Subject: License Amendment Request #8 (LAR 1014-8) to HI-STORM 100 Certificate of Compliance

Document ID: 5014692

**Attachment 1 to Holtec Letter 5014692**  
**LAR 1014-8, REVISION 0**

**SUMMARY OF PROPOSED CHANGES**

**Figure 2.1-4**  
**Fuel Loading Regions - MPC-68/68FF/68M**

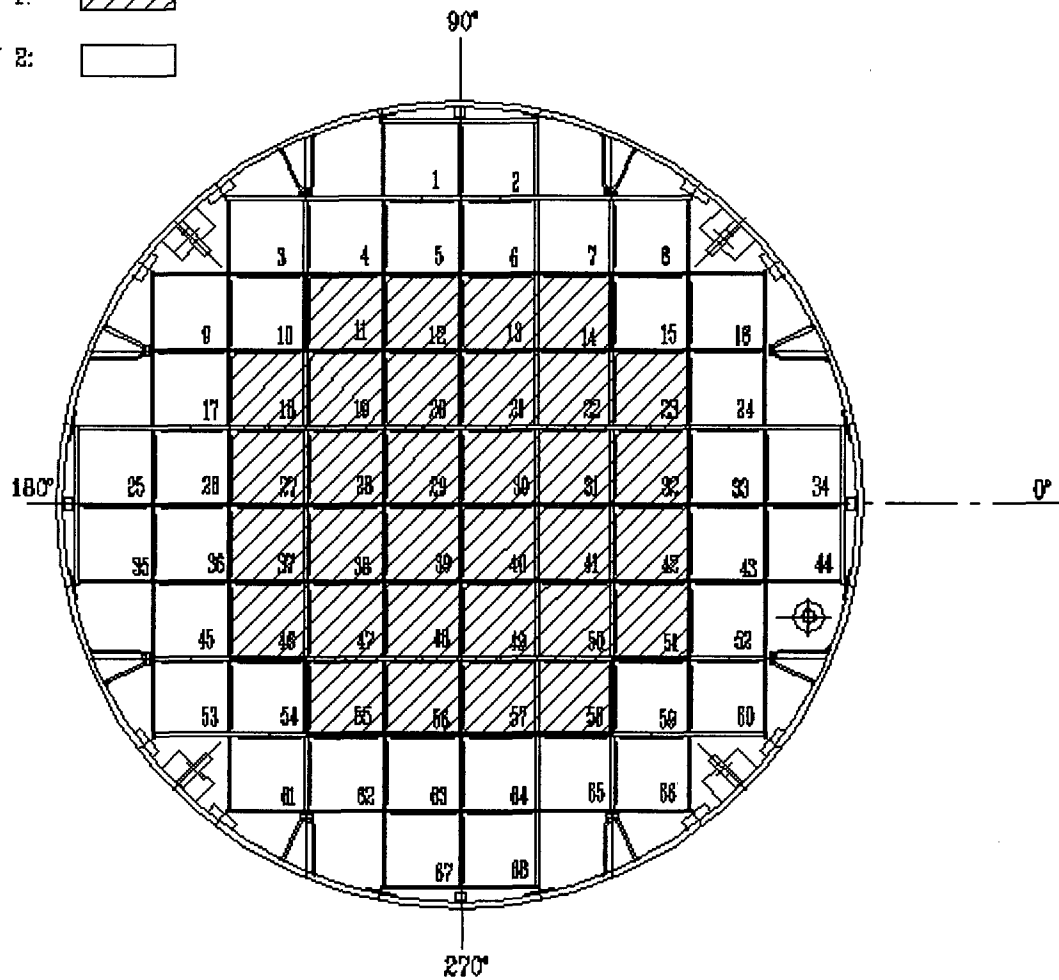
- 1.11. Appendix B, Figure 2.1-4; Added MPC-68M to the title of the figure.
  - 1.12. Appendix B, Table 2.1-1; Added Section VI. Allowable Contents and Quantity for the MPC-68M model.

- 1.10. Regionalized fuel loading is allowed for the MPC-68M.
- 1.11. As noted in the footnote on page 2-2, the figures (2.1-1 through 2.1-4) are only intended to distinguish the fuel loading regions. Other details of the basket design are illustrative and may not reflect the actual basket design details. Figure 2.1-4 indicates the cell numbers and regions of the MPC-68, 68F, and 68F. This numbering scheme also applies to the MPC-68M even though the basket internals are not exactly depicted exactly. The depiction of the MPC-68M basket and internals is provided in licensing drawing 7195R3 (Attachment 4).
